FINAL REPORT – INSPECTION 2009-12910-05 – PEER REVIEW OF JOHNSONVILLE FOSSIL PLANT DIKE STABILITY IMPROVEMENTS

**Peer Review of Stantec Consulting Services, Inc.
Plans for Construction - Northeast Dike Stability Improvements
Ash Disposal Area No. 2**

**Tennessee Valley Authority Johnsonville Fossil Plant (JOF)
New Johnsonville, Humphreys County, Tennessee**

Peer Review of Stantec Consulting Services, Inc. (Stantec)
Plans for Construction - Northeast Dike Stability Improvements
Ash Disposal Area No. 2
Johnsonville Fossil (JOF) Plant
New Johnsonville, Humphreys County, Tennessee
Revision R1 dated March 12, 2010, and Calculation Package dated January 26, 2010

Photo 11

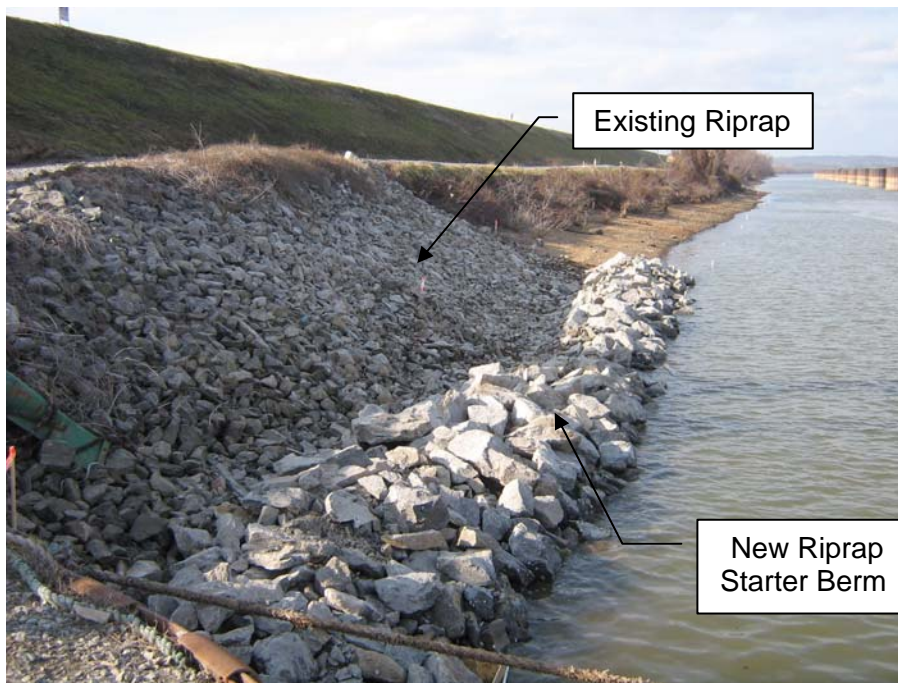
Item 9.1 and 9.2 - Second bullets - MM Findings and Recommendation: *On Drawing No. 10W503-03, Stantec specifies placement of the graded filter on top of existing riprap. The bottom layer of the graded filter consists of Tennessee Department of Transportation (TDOT) fine aggregate for concrete (Section 903.01 Standard Specifications for Road and Bridge Construction), which is not suitable for placement against the existing riprap. This fine aggregate will be prone to migrate through the relatively large voids of the existing riprap, thereby compromising the graded filter. Where the graded filter is proposed over the existing riprap, Marshall Miller recommends that a coarser aggregate filter layer be used directly against the existing riprap in lieu of the TDOT fine aggregate (sand) for concrete.*

Stantec Response: As indicated above, construction of this project was completed in August, 2010. The existing riprap pieces were typically relatively small (about 6 to 10 inches maximum size) and the riprap displayed a pre-existing "choked" surface where voids were mostly filled with smaller stone or sediment. During placement of the graded filter over the existing riprap, the Contractor made efforts to adequately spread sand and fill the remaining riprap voids prior to placing subsequent filter layers. Based on these observations and efforts, it is Stantec's opinion that an adequate filter system was constructed over the existing riprap. See attached Photos 11 and 12 which illustrate filter construction in this area.

Slope interval containing the existing riprap prior to remedial construction. The existing riprap is relatively small (maximum size ~ 6”).
